33, 37, 39, 41 and 43 Centre Avenue – Official Plan Amendment Application – Preliminary Report

Date: October 27, 2021

From: Director, Community Planning, North York District

Planning Application Number: 20 232921 NNY 18 OZ

Attachment 4: Site Plan

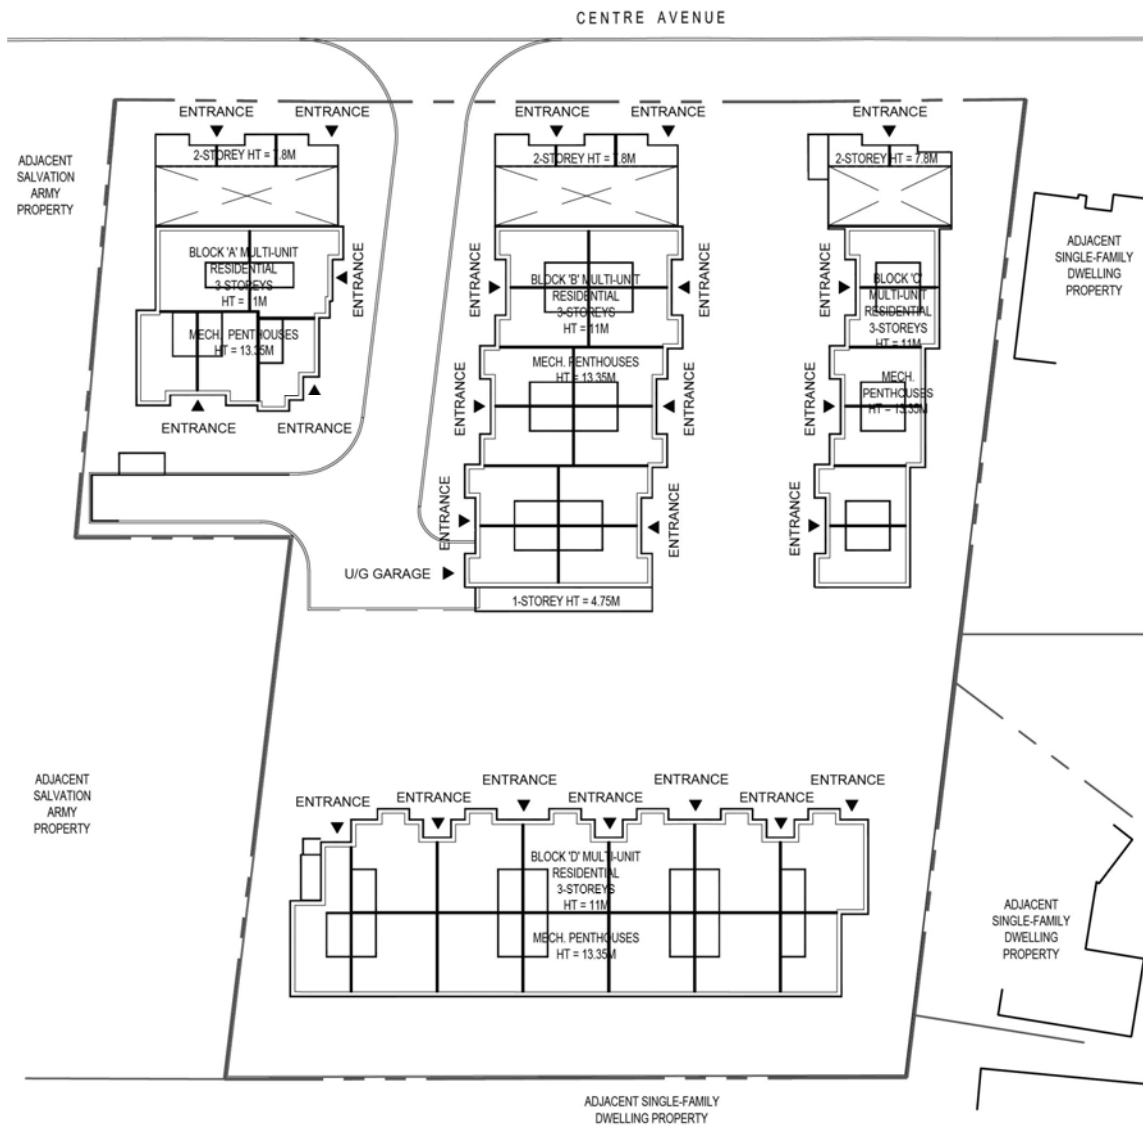
In the Preliminary Report, staff raised concerns with the organization of the proposed buildings on the subject site, as the southernmost buildings, Buildings D and E, were not visible from Centre Avenue and did not have a relationship with the public realm. The revised proposal now contemplates a single building, Building D, at the southern end of the site. Building D would be visible from Centre Avenue through the expanded

The previous proposal included pedestrian walkways along the eastern and western property lines of the site, which provided access to primary unit entrances facing the property lines. Staff had noted concern with the number of unit entrances located along the property lines, where sightlines and visibility would be poor. Staff had encouraged the applicant to locate primary unit entrances within highly visible areas of the site, including off Centre Avenue, the site driveway, or the central courtyard. In the applicant's revised proposal, all unit entrances now front onto either Centre Avenue, the site driveway or the central courtyard. Since there are no longer unit entrances along the eastern and western property lines, the pedestrian walkways in these locations have been removed and replaced with rear landscaped yards. Further, the reduced footprints of Buildings A, B and C enabled the minimum separation distance between Buildings A and B to be increased from 11.0 metres to 14.47 metres, allowing for a landscaped streetscape to enhance the unit entrances fronting the site driveway.

The below-grade units included in the previous proposal caused a number of issues that staff identified in the Preliminary Report. The Townhouse and Low-Rise Apartment Guidelines indicate that below-grade entrances and terraces are to be avoided in landscaped walkways and open spaces, such as the proposed central courtyard. The below-grade patios proposed off the central courtyard risked "over-privatizing" the area and prevented adequate landscaping. Staff were concerned that the below-grade patios would greatly limit opportunities to improve the design and functionality of the central courtyard. In response to staff's concerns, the applicant revised their proposal to remove the below-grade patios and widen the central courtyard in order to improve its design and function as a common landscaped amenity area. The revised proposal proposes window wells fronting the central courtyard to allow light into the basements. Staff are continuing to work with the applicant on the design of the window wells to ensure they do not impact the purpose or function of the central courtyard.

The revised proposal includes window wells throughout the site to provide light to the basement levels. Staff have asked the applicant to provide additional details on the size and design of the proposed window wells, as staff are concerned about the impact they will have, particularly on the central courtyard and along the Centre Avenue frontage. Staff have also asked the applicant to provide further information on the programming of the central courtyard.

Staff believe the modifications made to the building footprints and unit arrangement represent an improvement over the previous proposal. With the widening of the central courtyard and reduced width of Buildings A, B and C, Building D has an improved relationship to Centre Avenue in the revised proposal. However, staff continue to have concerns with the design of Building A, particularly with the units fronting onto the proposed loading and garbage area. Staff will continue to have discussions with the applicant regarding the design of this block and would like to see an improved interface for these units.

The Official Plan and Townhouse and Low-Rise Apartment Guidelines speak to locating servicing activities internal to buildings to minimize their impact on the property and on surrounding properties. The Preliminary Report had identified concerns with the Type 'G' loading space and garbage collection being located behind Building A and not internalized. The applicant's revised proposal has reduced the depth of Building A to provide increased separation distance from the loading and garbage area, and also to provide space for landscape buffering with a screen wall integrated into the exit stair enclosure. While staff recognize that this is an improvement from the previous proposal, staff would like to continue to work with the applicant to find design alternatives to minimize the impact of the servicing area.
